November 24, 2021

Subject: George Hall Elementary School HVAC Replacement
San Mateo - Foster City School District
Aedis Project No. 2021005.02
DSA Application #01-119523

ADDENDUM NO. 1

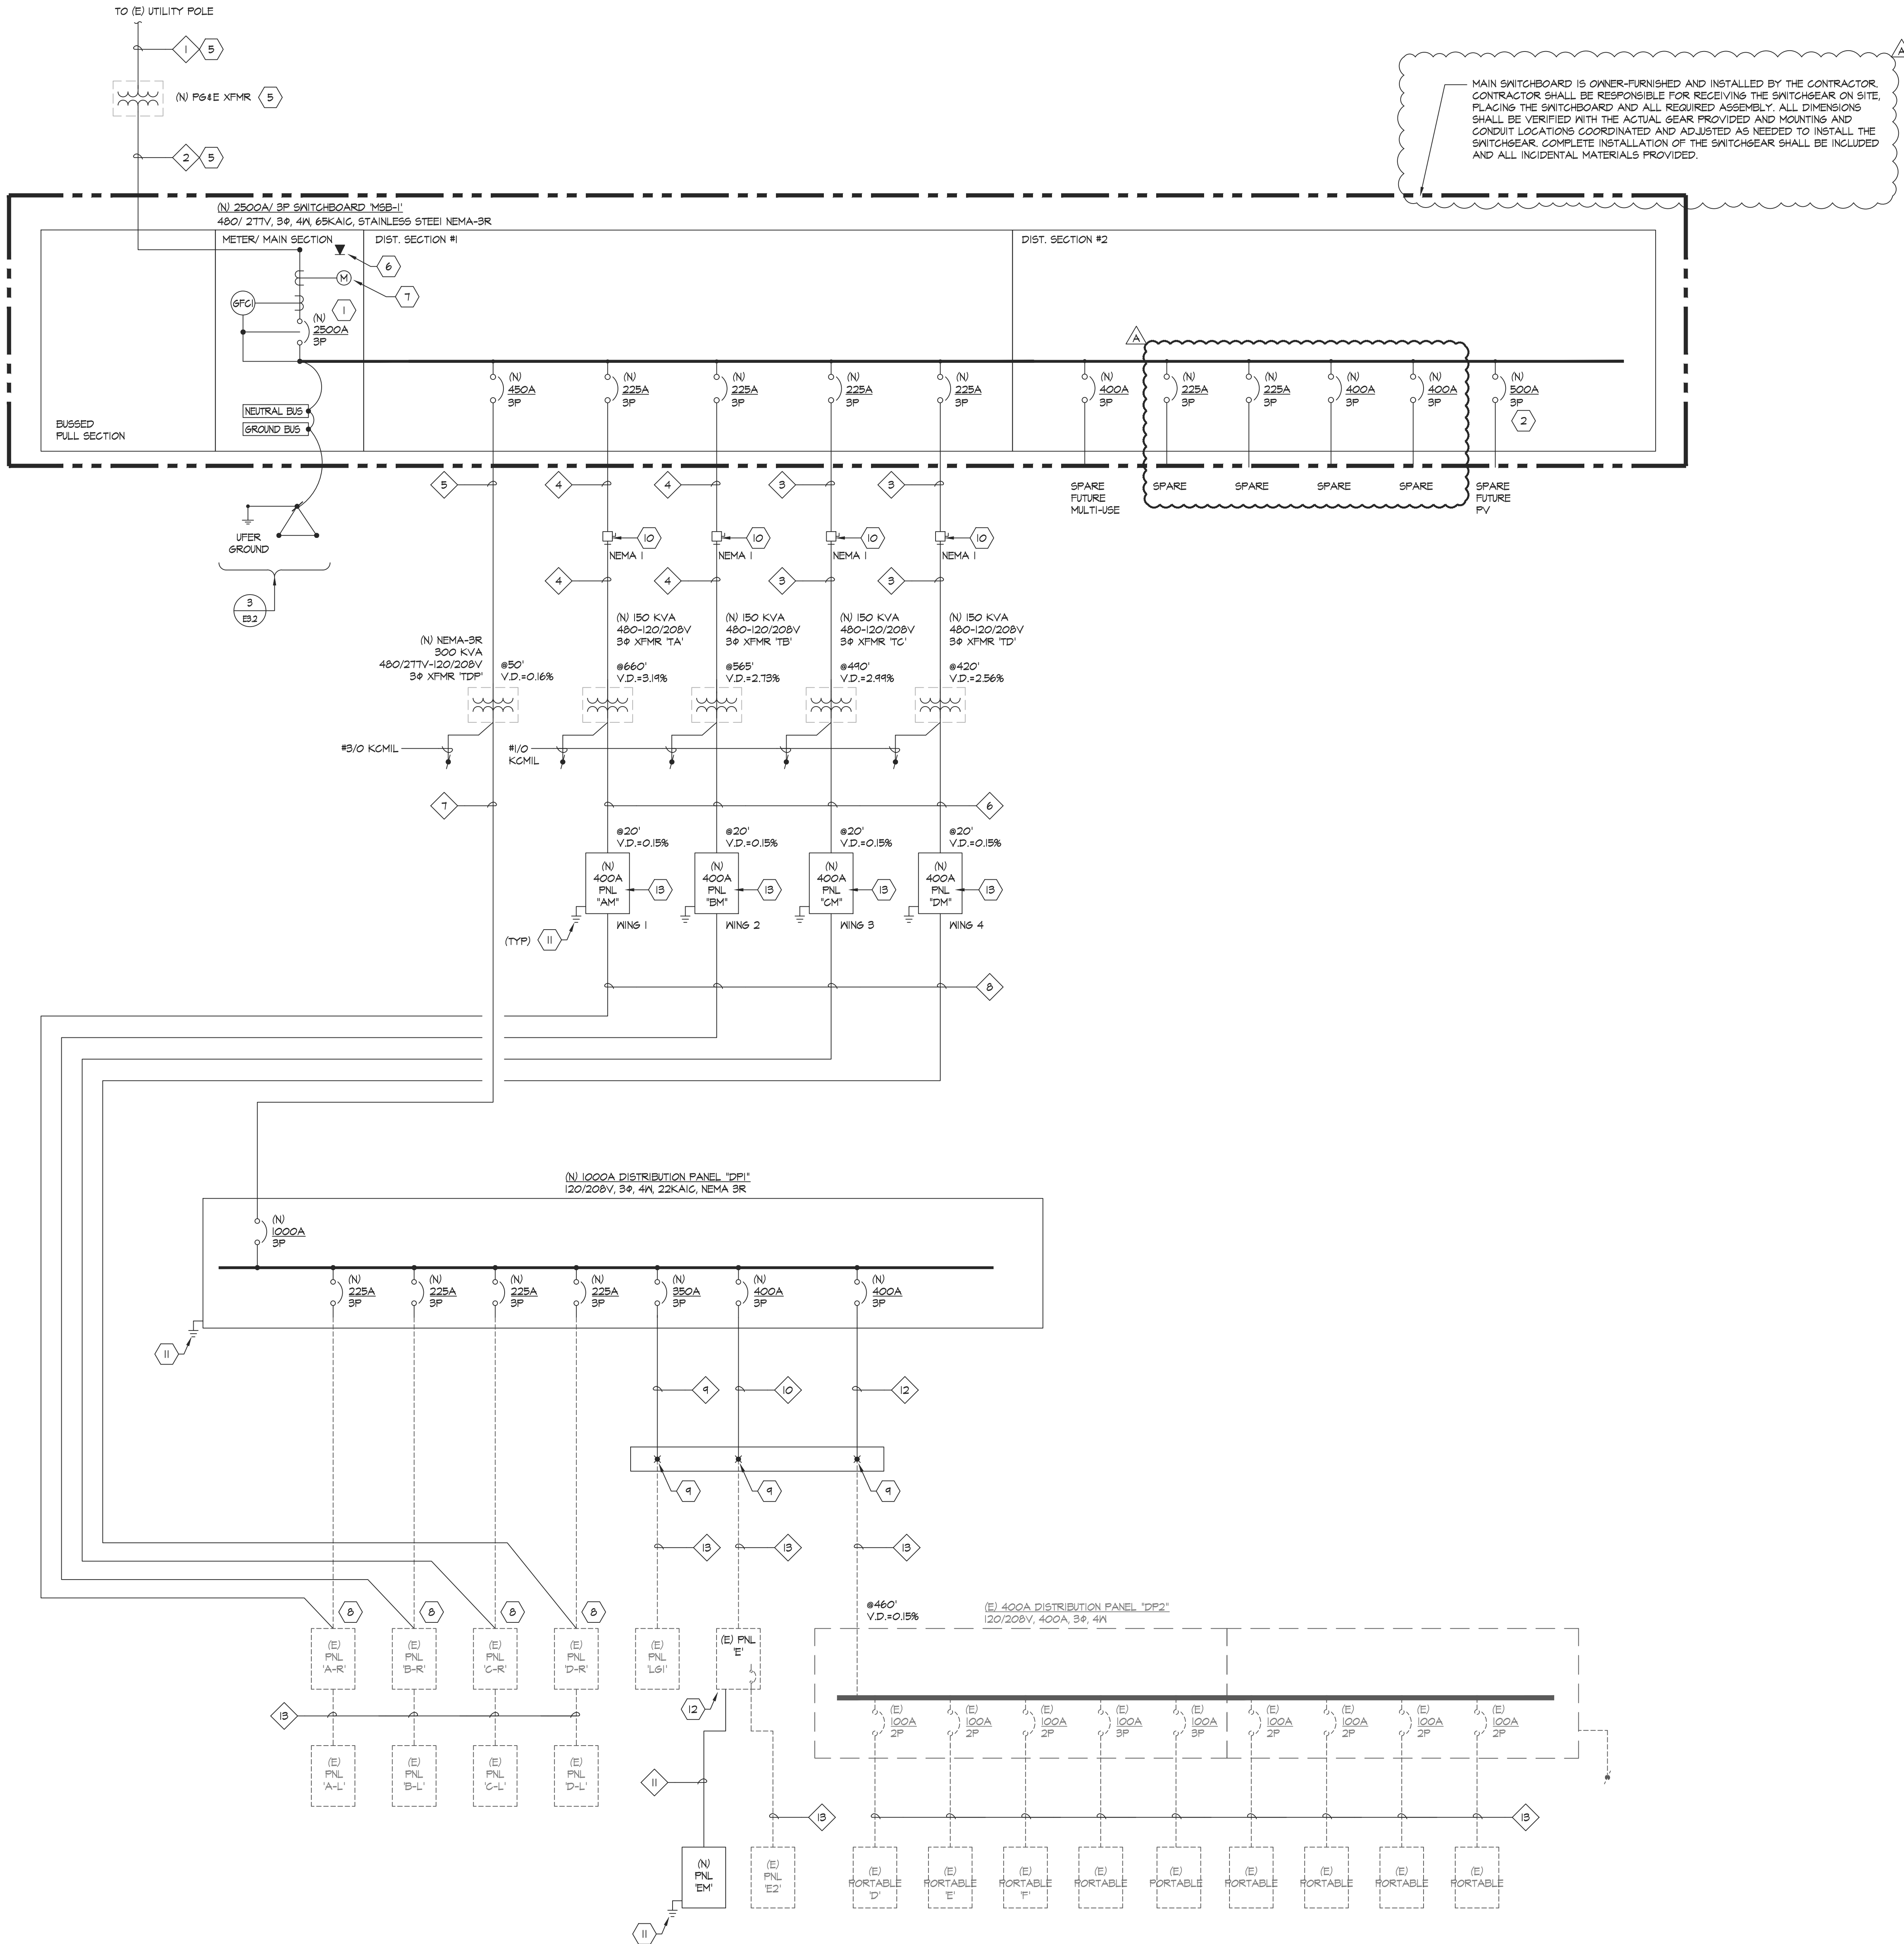
Revise: Switchboard to be OFCI per AD1-E4.2
